TVA-SQN-TS-00-06

SEQUOYAH NUCLEAR PLANT (SQN) - UNITS 1 AND 2 - REVISION OF INSTRUMENTATION MEASUREMENT RANGE, BORON CONCENTRATION LIMITS, REACTOR CORE LIMITATIONS, AND SPENT FUEL POOL STORAGE REQUIREMENTS FOR TRITIUM PRODUCTION CORES (TPCs) - TECHNICAL SPECIFICATION (TS) CHANGE NO. 00-06

PROPOSED TECHNICAL SPECIFICATION (TS) CHANGE TS 00-06 AND TPBAR CONSOLIDATION ACTIVITY DESCRIPTION AND EVALUATION OF THE PROPOSED CHANGE

Fig. 5.6-5 Limiting Burnup Requirements in Region 4, Checkerboard Array of 1 Fresh and 3 Type T Spent Fuel Assemblies

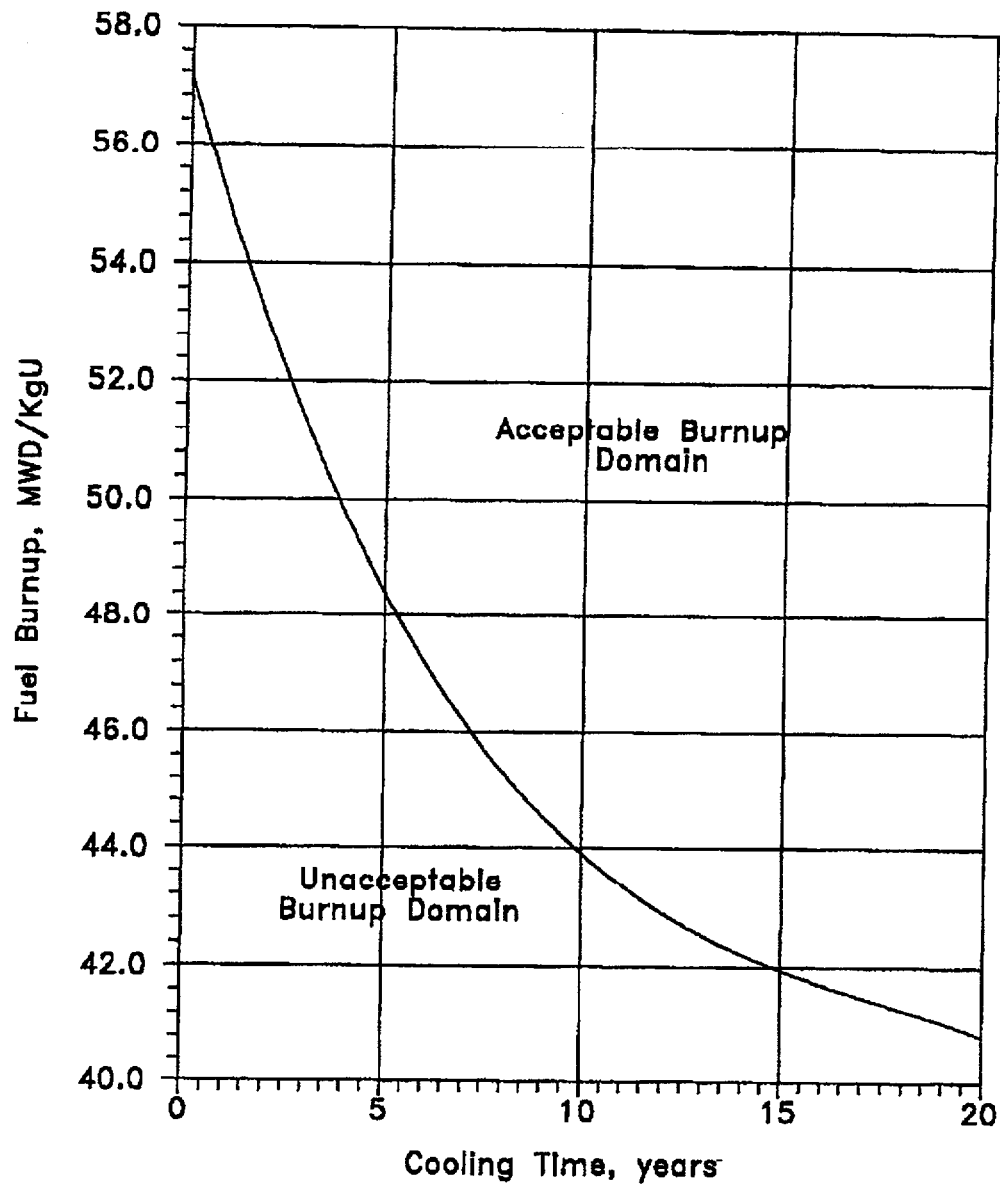
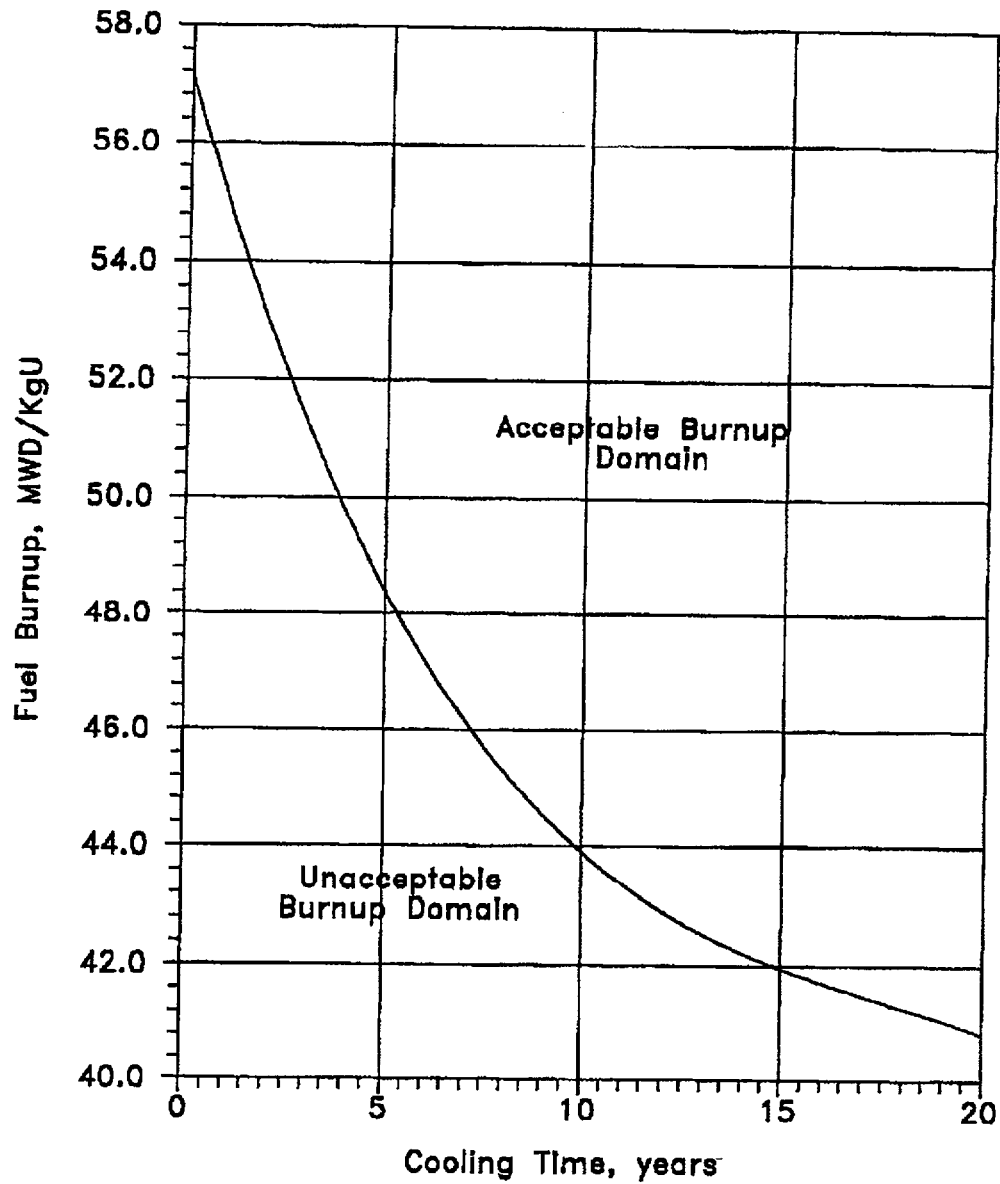
Insert 15

Fig. 5.6-6 Limiting Burnup Requirements in Region 4,
Checkerboard Array of 1 Fresh (with Gadolinia)
and 3 Type T Spent Fuel Assemblies

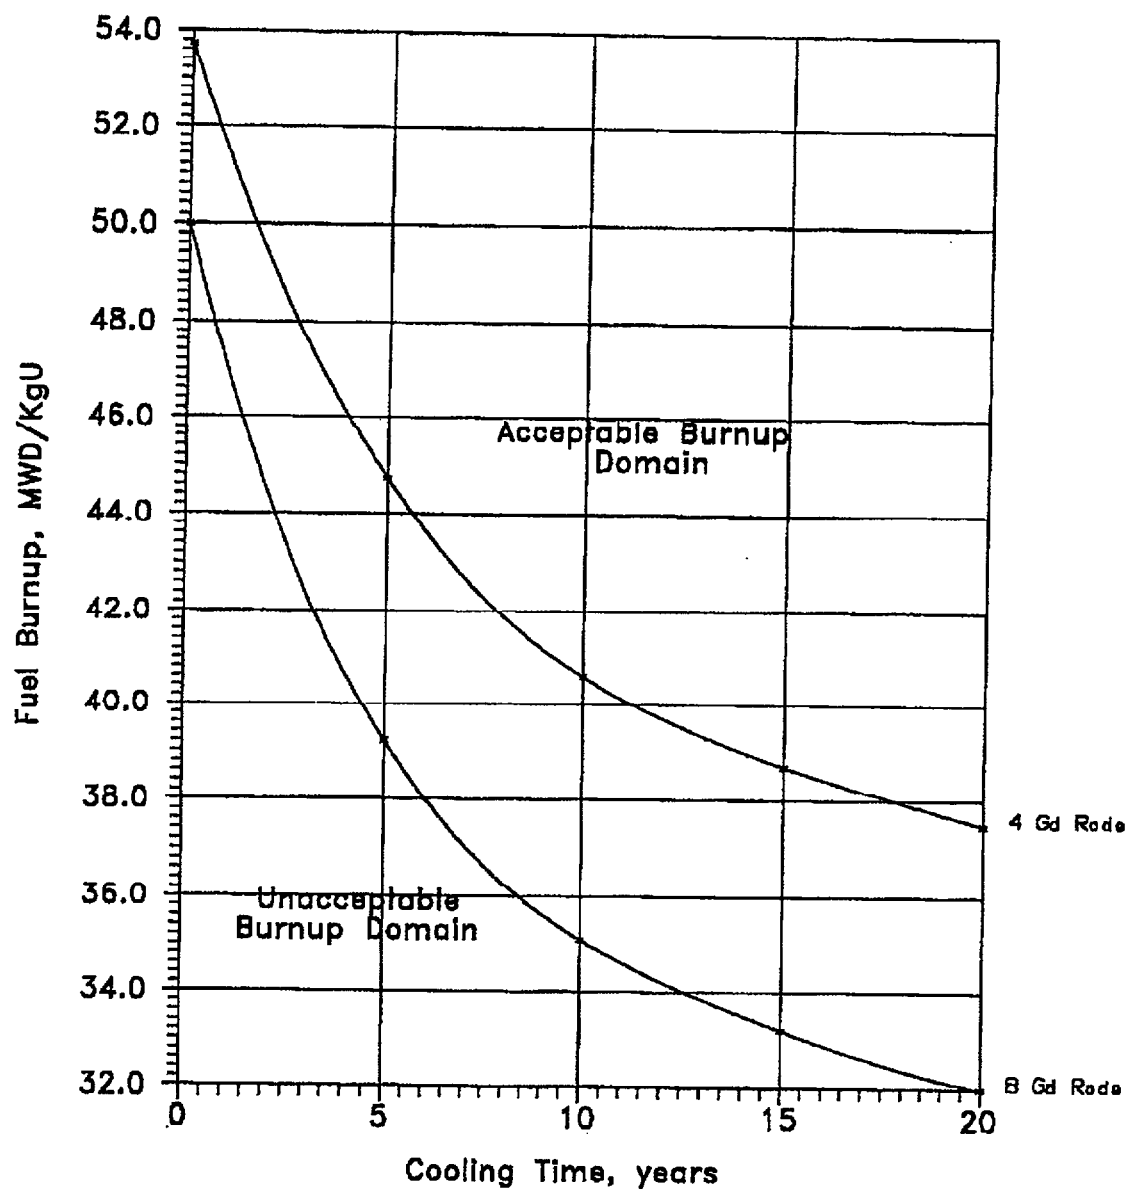
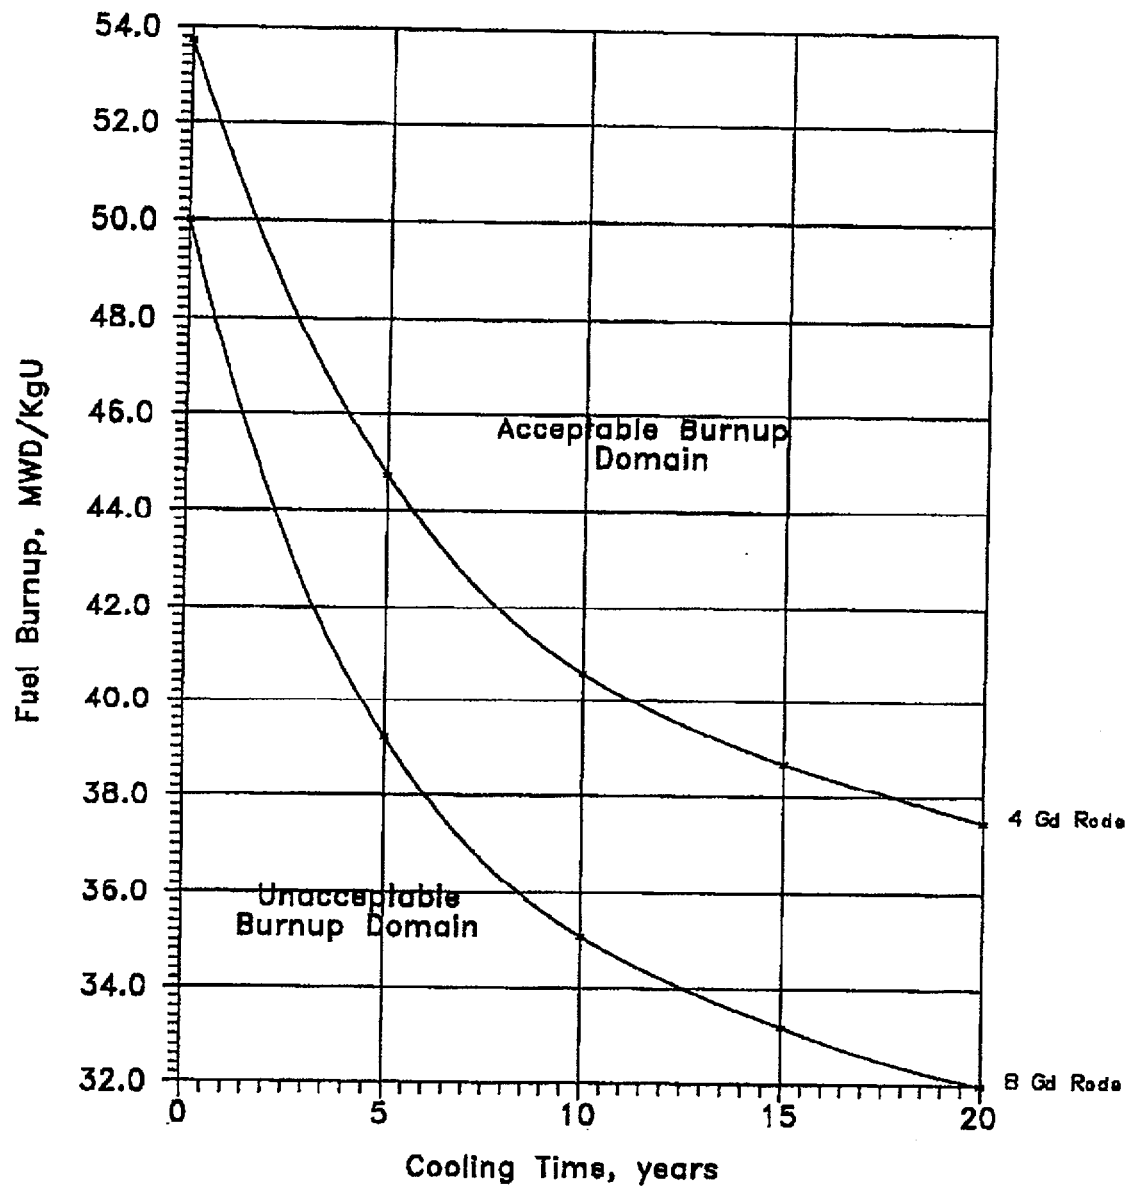
Insert 16
